Report to Planning and Environment Committee

Subject: 1176, 1180, 1182, & 1186 Huron Street & 294 Briarhill Avenue
Public Participation Meeting
City File No: OZ-9596 Ward 3

Date: June 19, 2023

Figure 2: Site concept plan

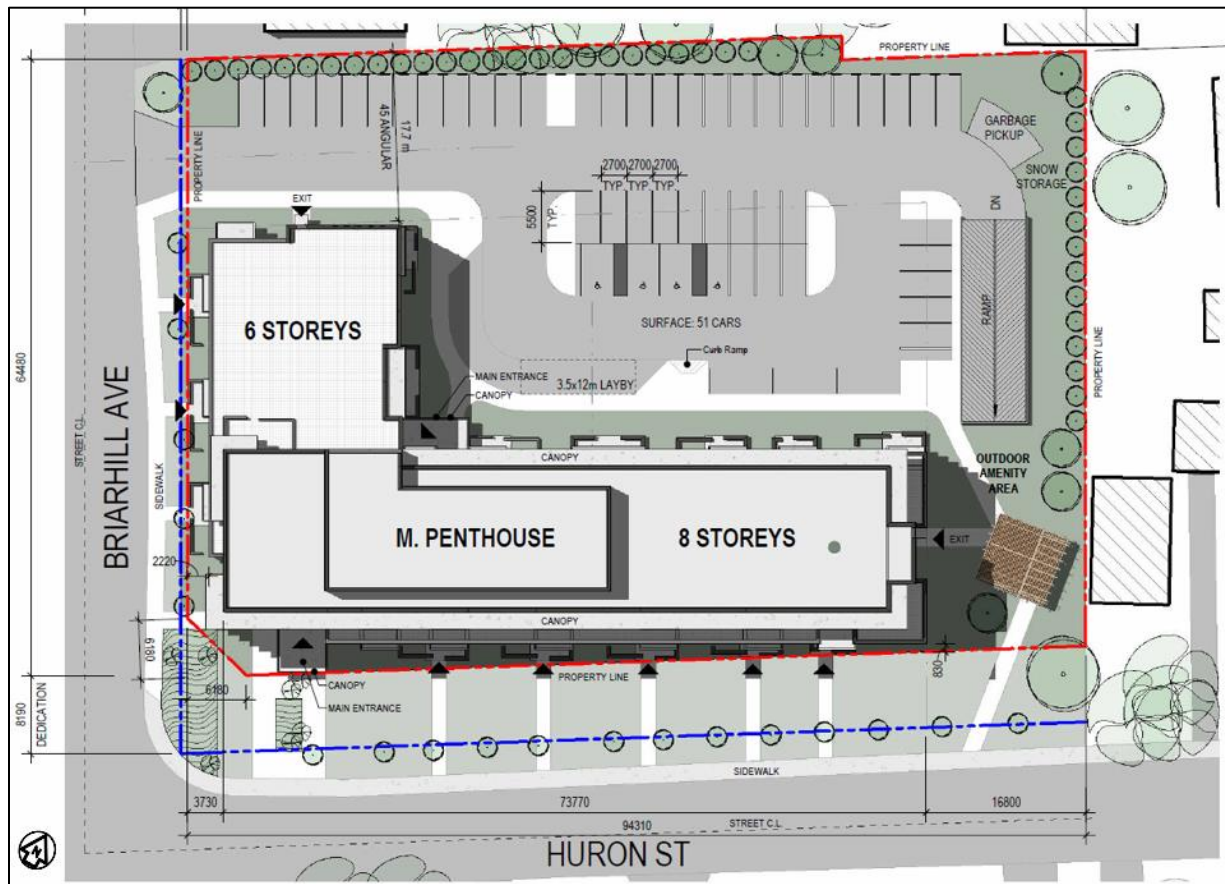
The southern setbacks are very tight. If the red line is the post-widened property line, they seem to be blurring the public-private realm. I'm curious about the site features they're showing beyond the red line – does the developer intend to make these site features then hand over maintenance to the City? Perhaps the City is willing to entertain this responsibility but this isn't a substitute for on-site tree planting/landscaping buffering the street. I'll leave this to you and Corby to discuss.

I don't mind the amenity space. However, I don't see an indication of how they'll handle that nearby ramp. I'm imagining kids running around. I figure OBC likely requires some guard for safety but additionally, the applicant may consider bushes to further section off this area.

- A reduction in surface parking will allow for a larger and more useful amenity space. The panel notes that in its current location, the amenity space will require noise mitigation. Consider providing a larger amenity space with a paved terrace and planter boxes along the north edge of the interior corner of the L-shaped building. The proposed amenity space at the east edge of the site could also remain, or be revised to a simple generous landscaped buffer space with walkways.

- The panel recommends consideration be given to relocating the parking ramp closer to the north side of the site, to make a better site configuration, a better condition for the suggested revised amenity space location noted above, and the pedestrian walkway proposed to connect from the Huron Street public sidewalk across the east side of the site to the rear of the building.

The current design strives to strike a balance between the provision of housing, green/amenity space and effectively using surface area for parking and vehicle circulation. As shown on the concept plan, 2/3 of all proposed parking located in the underground garage. We will continue to look at opportunities to reduce the amount of paved area at-grade as we get into detailed design through the Site Plan process.
